RE: One Riverside Street
(Motel Six)

Your application for interior renovations at Motel Six (office area) has been reviewed and a permit is herewith issued subject to the following requirements. This permit does not preclude the applicant from meeting applicable State and Federal laws.

SHEET TITLE:
PROPOSED FLOOR PLAN & DETAILS

MOTEL 6, L.P.
PROPOSED A.D.A./OFFICE-LOBBY ALTS
PORTLAND, MAINE

PROPOSED OFFICE/LOBBY FLOOR PLAN

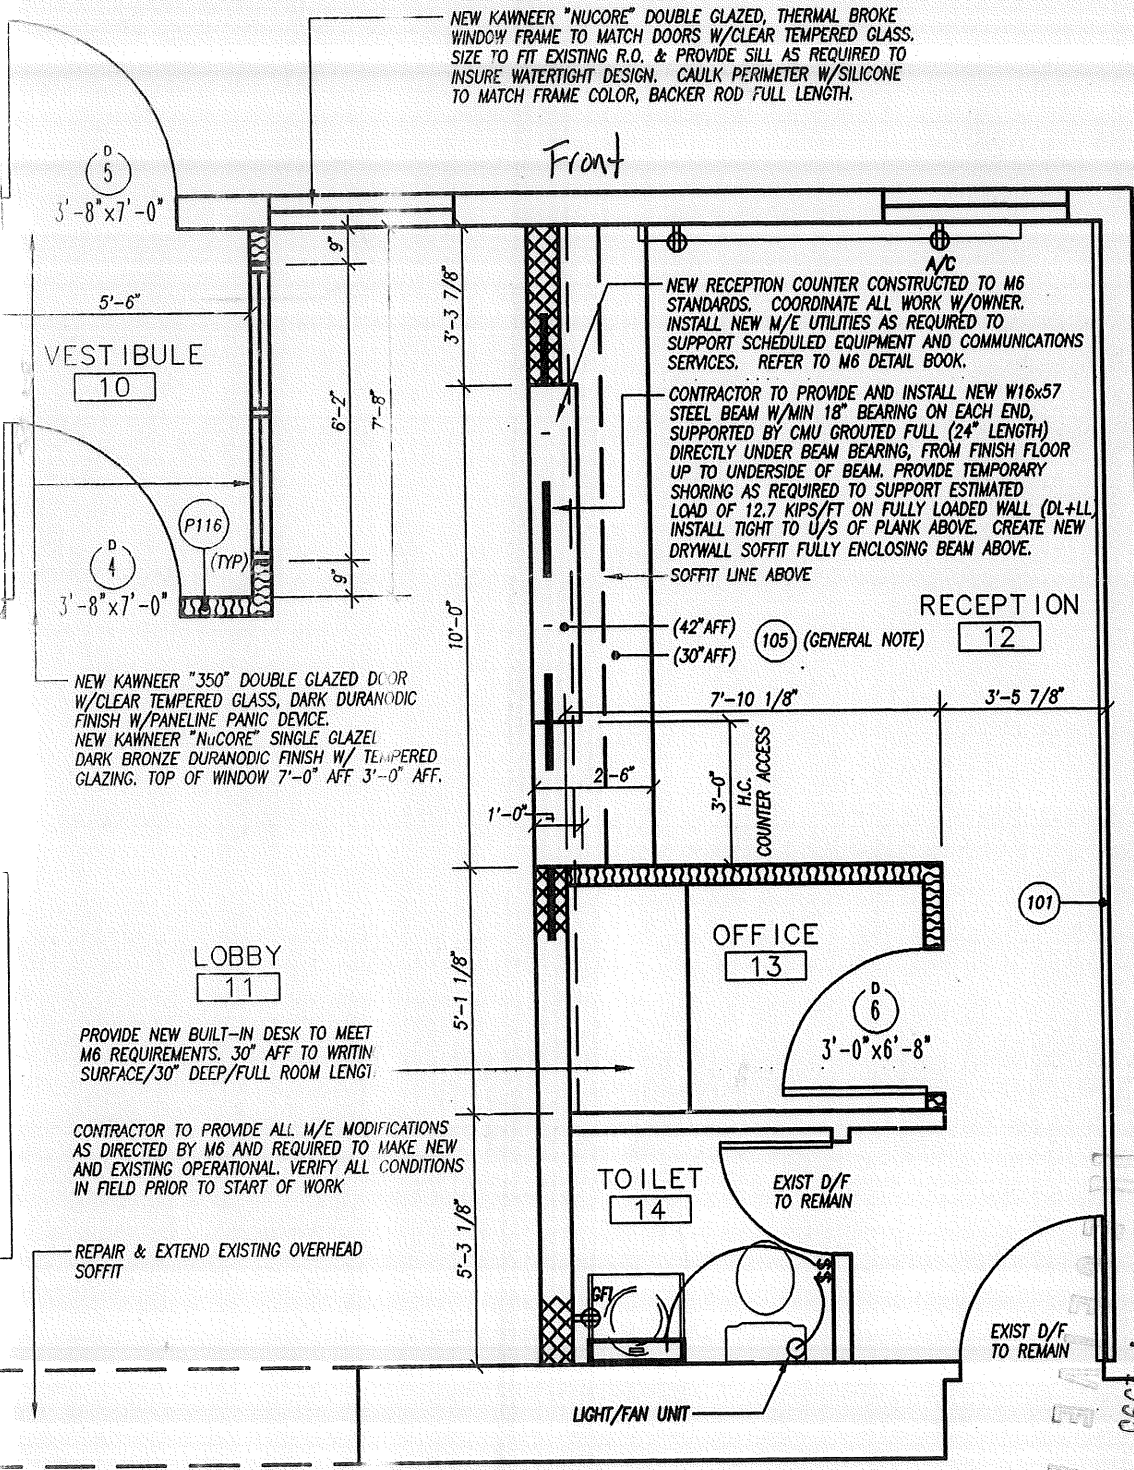
- The sprinkler system shall be maintained to NFPA #13 standards.
- The fire alarm system shall be maintained to NFPA #72 standards.
- Your plan did not show on bear the seal of a structural engineer or registered architect on the approved steel beam. Please submit this very important information before work begins.
- ✓ - The proposed steel beam must have a minimum fire resistance rating of two hours.
- ✓ - When the beam is in place but before covering, call Mr. Carroll at this office for inspections at 874-8300, ext. 8708.
